COUNCIL ASSESSMENT REPORT

Panel Reference	2017HCC059
DA Number	DA2017/01546
LGA	Newcastle
Proposed Development	Alterations and additions to car park to include medical centre
Street Address	Lot 1 DP 1027546, Lot 2 DP 1027546, Lot 3 DP 1027546 and Lot 7 DP 741487 6-8 Lingard Street Merewether
Applicant/Owner	KDC Pty Ltd / Vital Healthcare Australian Property Pty Ltd
Date of DA lodgement	8 December 2017
Number of Submissions	Four
Zoning	B5 Business Development
Recommendation	Refusal
Regional Development Criteria	Pursuant to Schedule 7 of the State Environmental Planning Policy (State and Regional Development) 2011, the application is referred to the JRPP as the proposed development is a health services facility with a capital investment value over \$5 million.
List of All Relevant Section 4.15 (1)(a) Matters	<p>Environmental planning instruments: s4.15(1)(a)(i)</p> <ul style="list-style-type: none"> • State Environmental Planning Policy (State and Regional Development) 2011 • State Environmental Planning Policy (Infrastructure) 2007 • State Environmental Planning Policy No. 55 - Remediation of Land • State Environmental Planning Policy No. 71 - Coastal Protection • Newcastle Local E

Figure 3 - Height of Buildings Map Extract - extracted from Statement of Environmental Effects

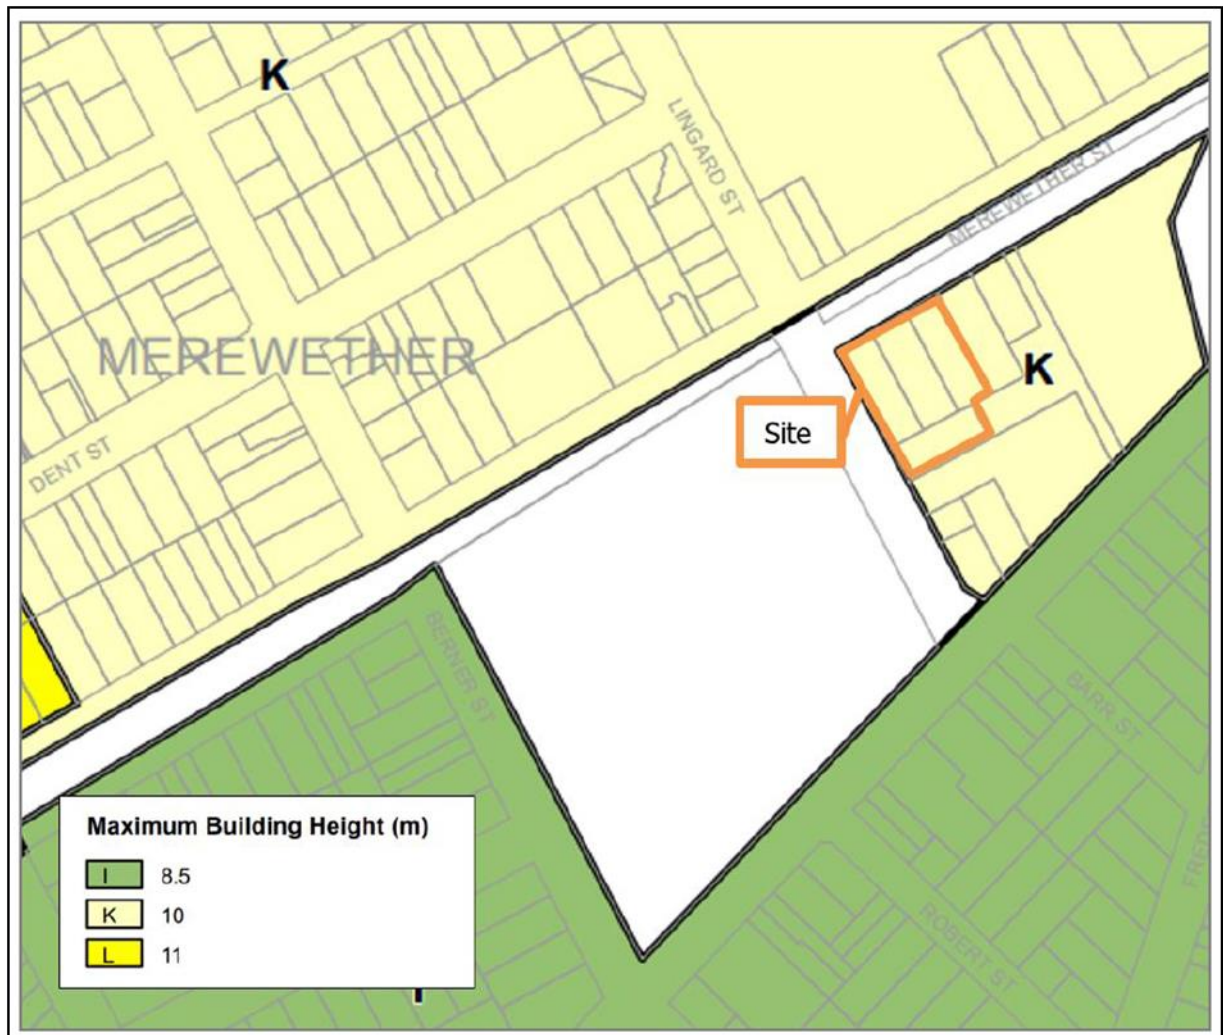
The Height of Buildings Map has a maximum height standard for the site of 10m (as shown in Figure 3). The proposed development has a maximum height of 16.14m to the top of plant and 14.06m for the main building. This represents a variation of 61.4% and 40.6% respectively to the height of buildings development standard.

It is not accepted that the height "*exceedance is largely due to the plant deck which is setback from the street level in the centre of the building*". The submitted plans and submitted Clause 4.6 variation request both clearly show that the proposed parapet and wall, for the majority building, are over 14m in height (ie 4m in excess of the 10m height of building development standard) with very little setback from the street (ie 0.9-2.59m) or side boundaries. It is further noted that the larger plant room on the south eastern side of the building is only setback 2.91m from the edge of the building and at over 16m in height (ie over 2 metres higher than the 14m main building wall height) would be a visible element contributing to the overall height, bulk and scale of the proposed development.

The discussion regarding the "*regulated height requirements of surgical rooms and operating theatres*" and the need for 4.2 metre ceiling heights is noted, but is considered to not be a basis to justify a variation to the 10m height standard. A two level proposal on the site could have been readily designed with 4.2m ceiling height and would have been compliant with the 10m height standard. The current development has been designed with all the plant room and the majority of a full floor level above the 10 metre height standard.

Figure 4 - Floor Space Ratio Map Extract - extracted from Statement of Environmental Effects

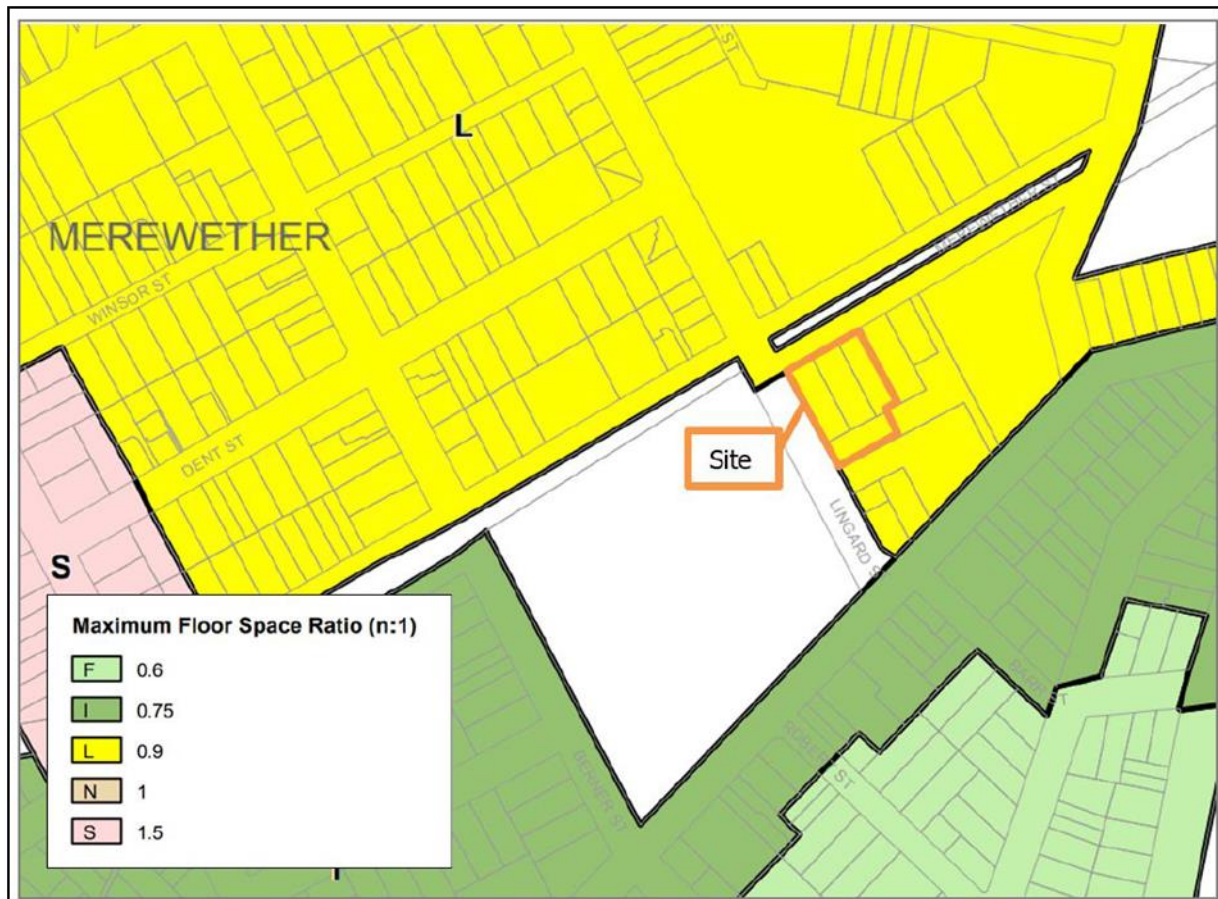
The maximum floor space ratio for the site is 0.9:1 (as shown in Figure 4). The proposed development has a floor space ratio of between 1.61:1 (approximately 78.9% variation) and 1.695:1 (1.7:1) (approximately 88.35% variation), based on Council's assessment of the application, and does not comply with the FSR development standard.

Notwithstanding this, it is considered, based on Council's calculations, that the proposed FSR is 1.61:1 and the current Clause 4.6 request is proposed on the correct magnitude of variation. It is notable that if the interpretation of 'gross floor area' was taken to be inclusive of proposed parking variations (ie as opposed to adopted rates, as discussed above) the proposed FSR would increase to 1.69:1.

4.2 Service Bay Use & Driveway Access for Service Bay

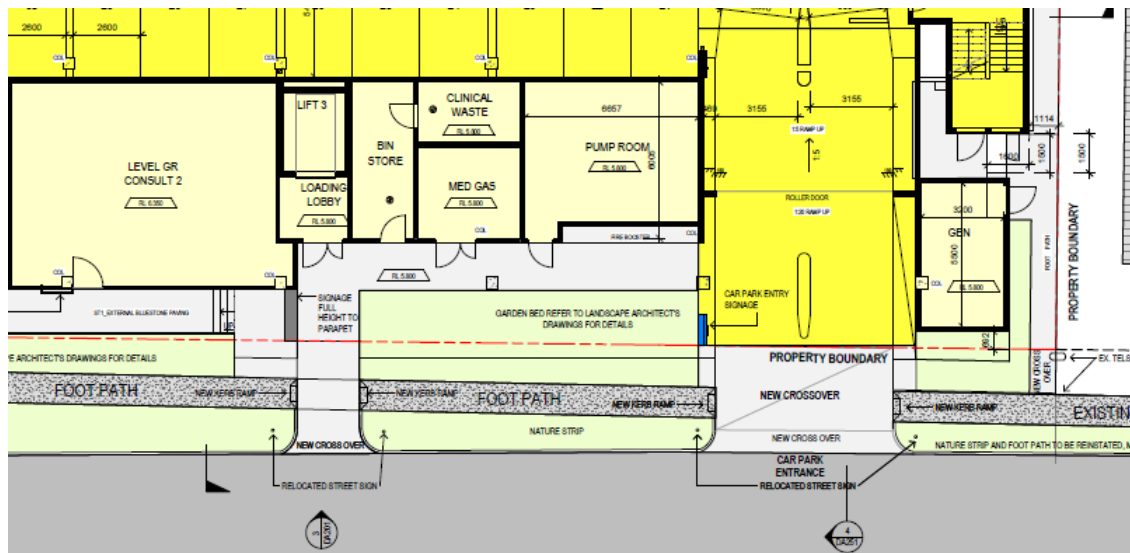
A new driveway is proposed for the service ramp and garbage pick-up. The submitted traffic report prepared by Intersect Traffic (Clause 11.5 briefs about the servicing) has stated that the proposed driveway will be used for servicing the development including private garbage pick-up. It is also assumed that servicing such as blood & heath test delivery, mail, general maintenance etc. may use the service bay (ie loading bay). The traffic report has not provided any information or data in regards to the frequency or number of potential vehicles using the service bay. Due to the nature of the development, it can be assumed that the proposed service bay and driveway will be regularly used and the service bay can be stated to be a Minor service area as per AS2890.2.

Neither the traffic report nor the SEE has indicated if any ambulance vehicles will be accessing the site. It is assumed that the ambulance may also use the service bay as Lift 3 links to the rest of the building via the loading lobby entry and service bay.
